Item No: C1222(1) Item 8

Subject: POST EXHIBITION - DRAFT DEVELOPMENT CONTROL PLAN - 469 - 483
BALMAIN ROAD, LILYFIELD

SITE-SPECIFIC DEVELOPMENT CONTROL PLAN

**Amendment 16 to Part G - Leichhardt Development
Control Plan 2013**

Figure 2 - Public domain, deep soil planting and pedestrian through site links (Draft Balmain Rd Site Specific DCP)

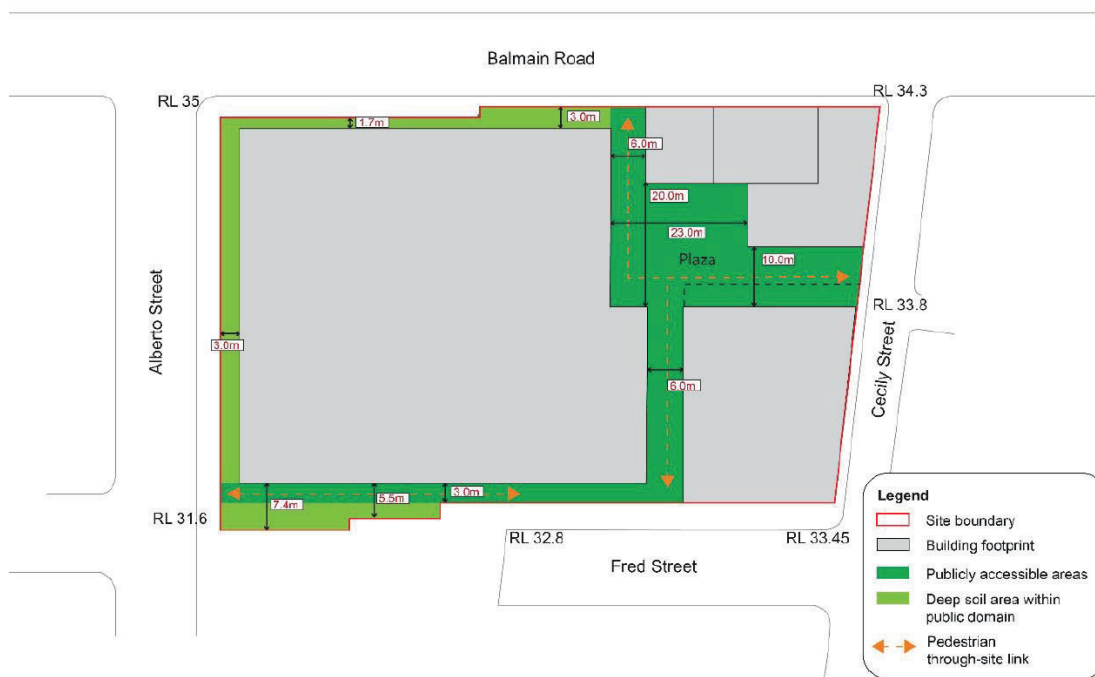
The lack of green space the project provides is appalling.	Noted. The requirement to provide 6,000m ² of employment space to match the existing provision of light industrial uses limits options for green space. Notwithstanding this, opportunities exist for green roofs, green walls and deep soil in the plaza and along the edge of the site. With a corrected Figure 5 amended (DCP May

Issue	Officer's comment
	2022) to match the FSR 2.2:1 and provide greater amount of podium green space shown in Figure 8, the footpath to Alberto Street shown in Figure 2 has been widened to provide better deep soil for mature trees.
<p>The proportion of site coverage to public domain is inadequate & not supported. The open space will be dwarfed by the bulk of the buildings. The passage spaces / pedestrian links are too narrow and will become wind tunnels and unpleasant dark spaces due to the height of buildings either side, particularly the link through to Fred St.</p>	<p>The proportion of site coverage to public domain was negotiated by the Eastern City Planning Panel, however additional open space could be obtained by reducing the building footprint and allowing some employment uses on the first floor. The distribution of land use can be further explored at development application stage.</p> <p>However, with a corrected Figure 5 (showing site plan) in May 2022 DCP to closer match the FSR 2.2:1, the footpath to Alberto Street has been widened to provide deep soil to support mature trees and the area of the plaza rationalised to provide clearer outcomes for built form and open space.</p>
